From: chris peterson <emailcrp@gmail.com>
Sent: Sunday, October 19, 2025 5:58 PM
To: Alfred Mittl <Fred.mittl@mysanibel.com>
Cc: Kevin McLellan <kbmclellan@gmail.com>
Subject: Periwinkle bridge project

Subject: Resident comments on the East Periwinkle Bridge project

Comments regarding East Periwinkle Way Bridge Replacement Project

Periwinkle Bridge Replacement Project
TYLin Response to Resident's Concerns
April 14, 2025

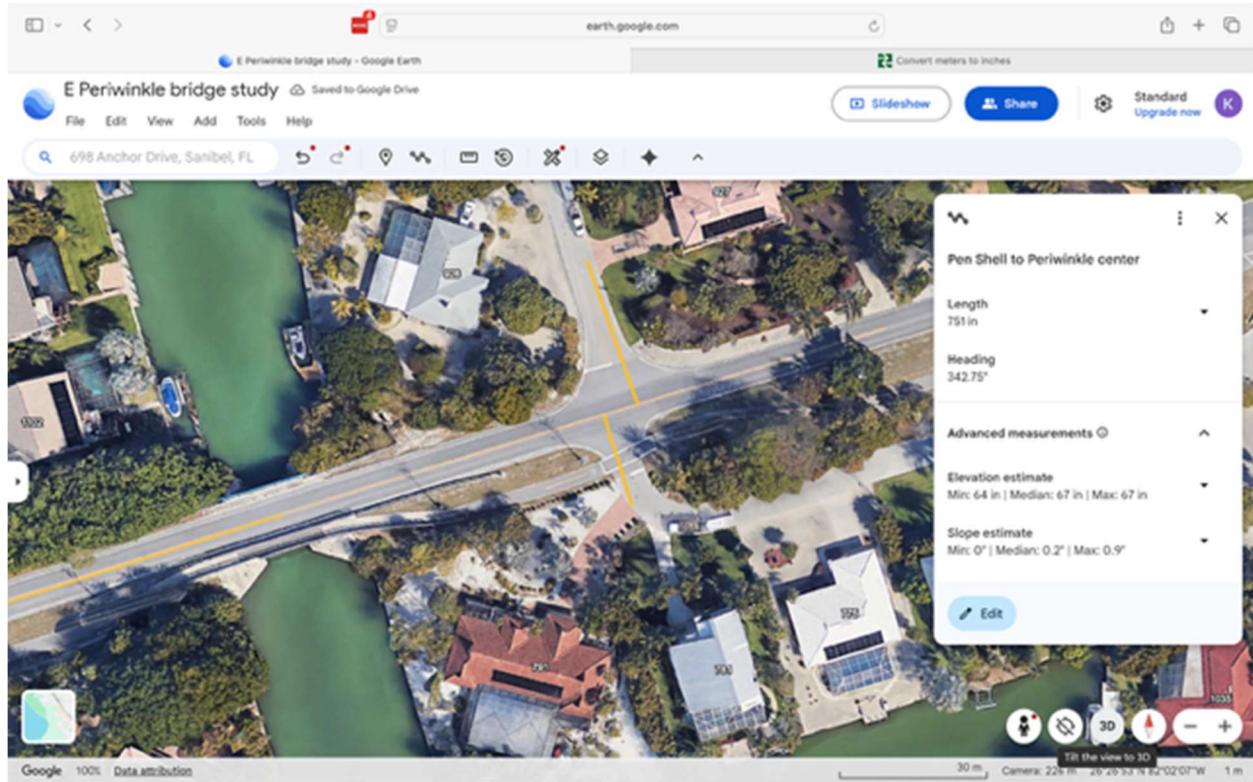
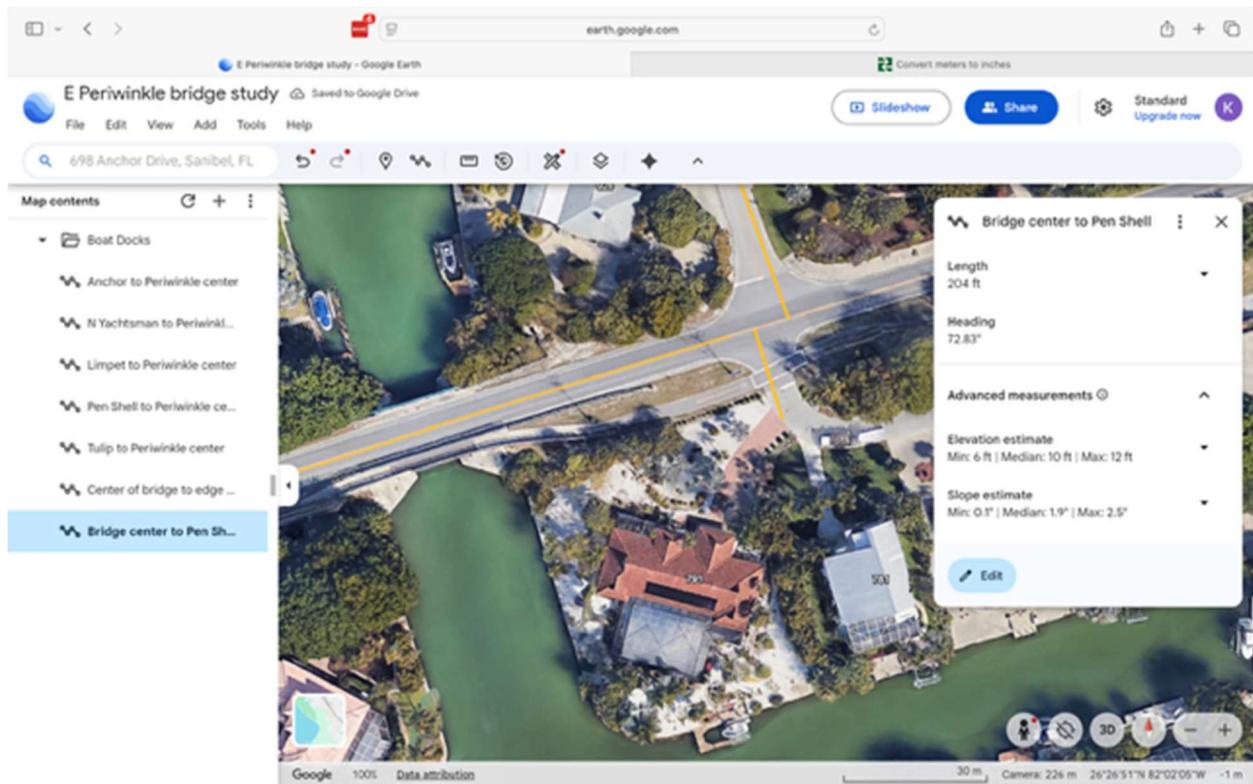
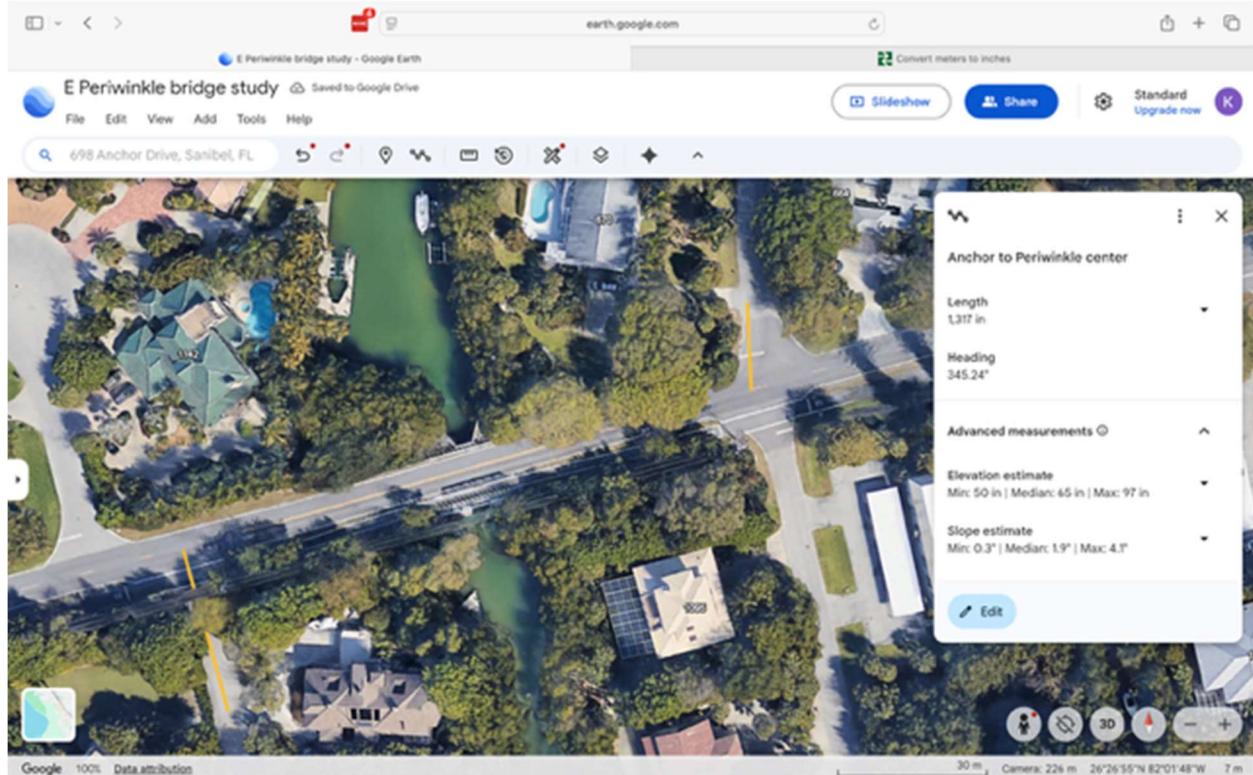
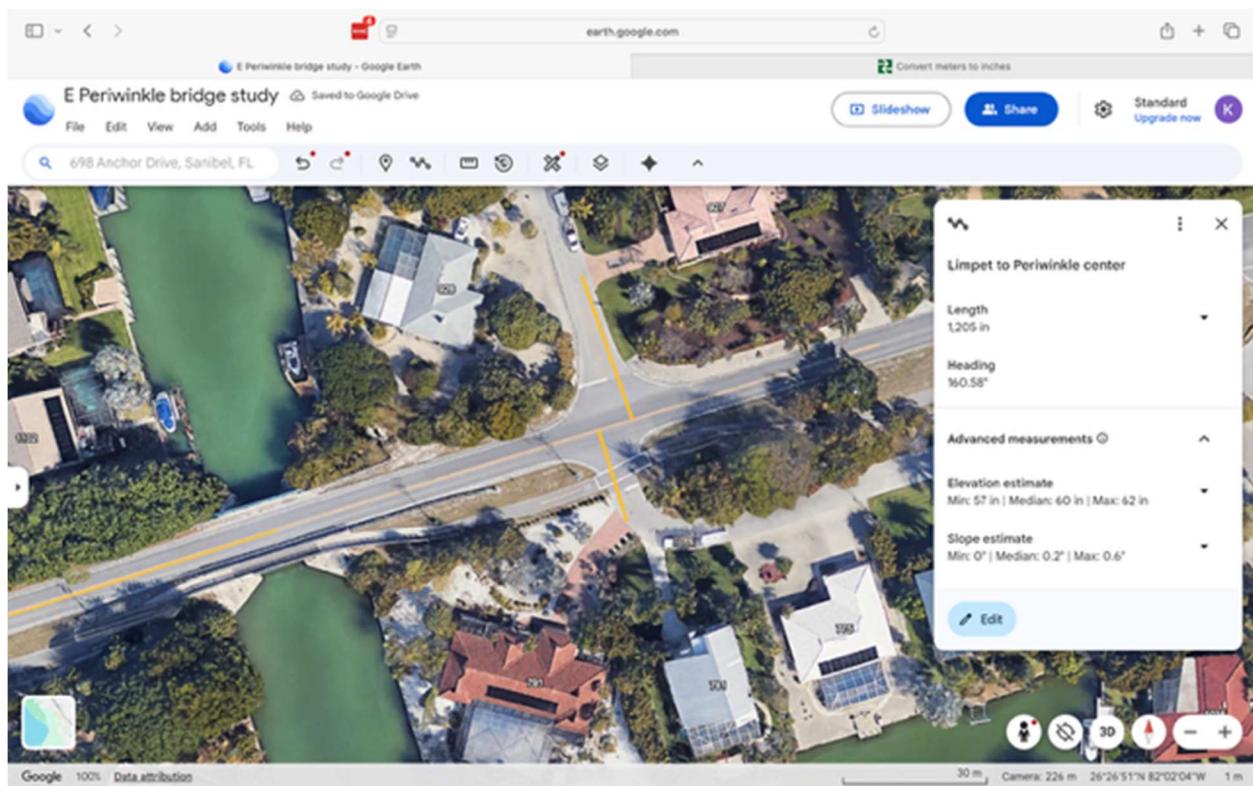
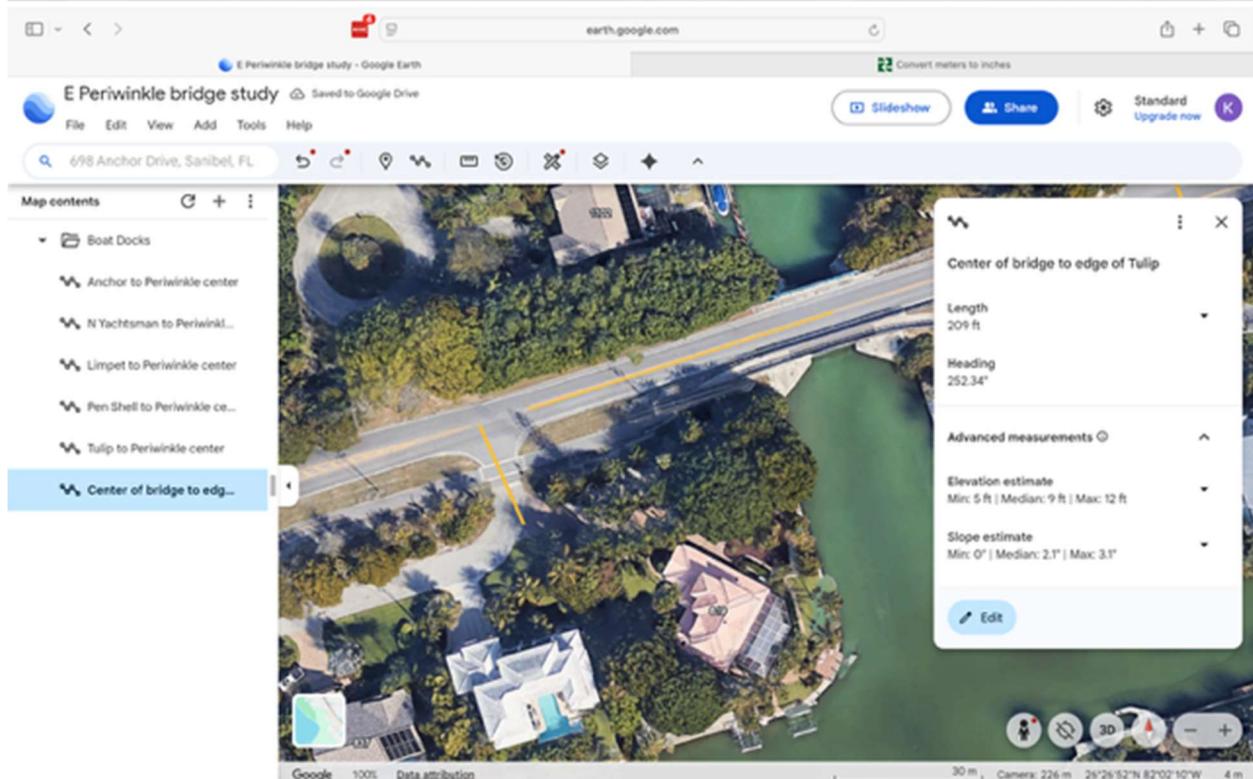
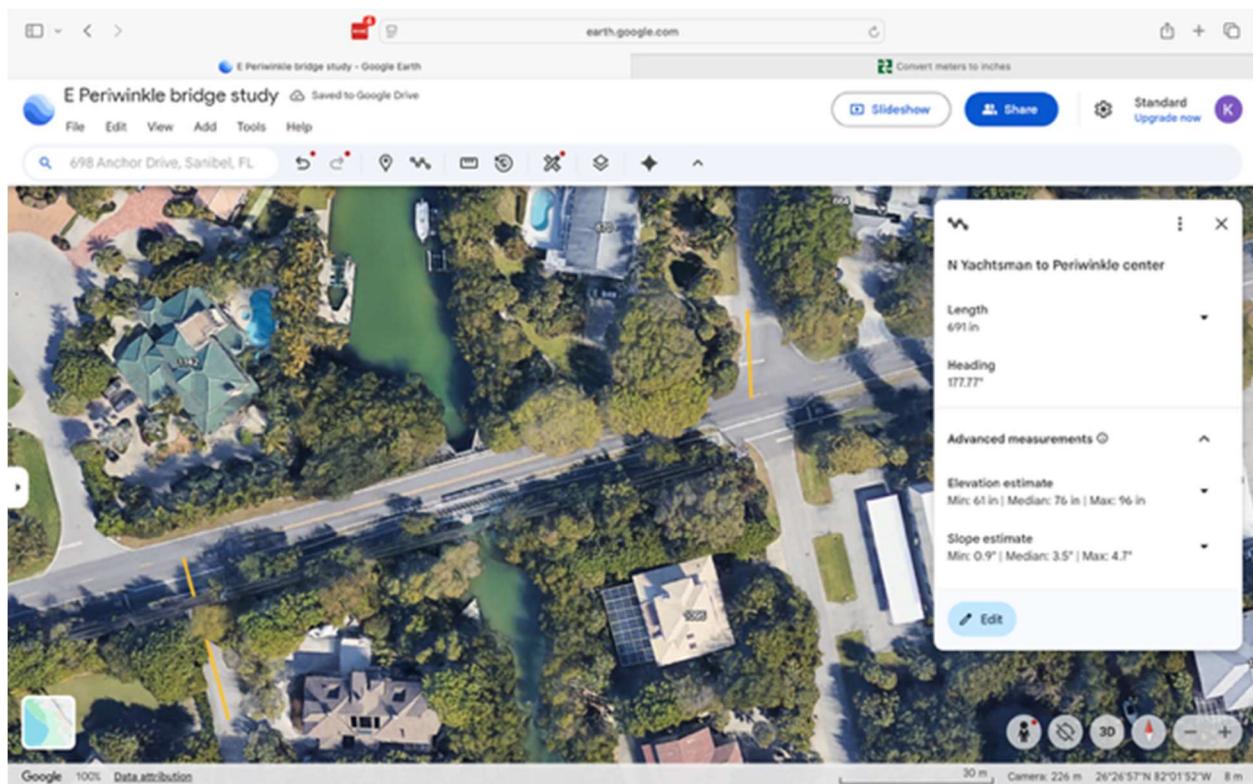
In addition to the letter sent by Chris Peterson, I am summarizing a Google Earth study that we conducted in the last 48 hours (post- meeting with the Public Works dept and TyLin engineering) of road height differences between Periwinkle and cross streets in the area. The public works and Tylin engineering teams mentioned concerns about "line of sight and access to abutting roads" and this study should address their concern. Specifically:

- The existing difference in road heights from Periwinkle to the cross streets at the nearest bridge (between N. Yachtsman Dr and Anchor Dr) range from +35" (N. Yachtsman to Periwinkle) to +47" (Anchor Dr to Periwinkle), almost four feet
- The existing difference in road heights adjacent to the E. Periwinkle bridge range from 3" (Pen Shell to Periwinkle) to 5" (Limpet to Periwinkle), less than a foot
- There is 200' from the center of the E Periwinkle bridge canal to either of the nearest two intersections (at Pen Shell and Tulip, to the East and West of the bridge, respectively), 400' total, more than twice the length of the current proposed bridge structure. If required, the new bridge could be extended to address concerns about slope which needs to be ~5 degrees for pedestrian access as we understand the regulation (per Tylin).

In fact, the difference in road height from Anchor to Periwinkle, almost four feet, has never been an issue for us (both Chris and I live on Anchor Dr) to the point where we had no idea it was so significant until we measured it.

Therefore, it is our strong recommendation that the city redesign the bridge and maximize canal navigational clearance by elevating the adjacent roadway. There are other options that could be considered (e.g., closing off the entrance to Pen Shell closest to the bridge;

it's already a duplicate access to the road) to ensure that we are able to increase the clearance of the bridge by 3' or more.
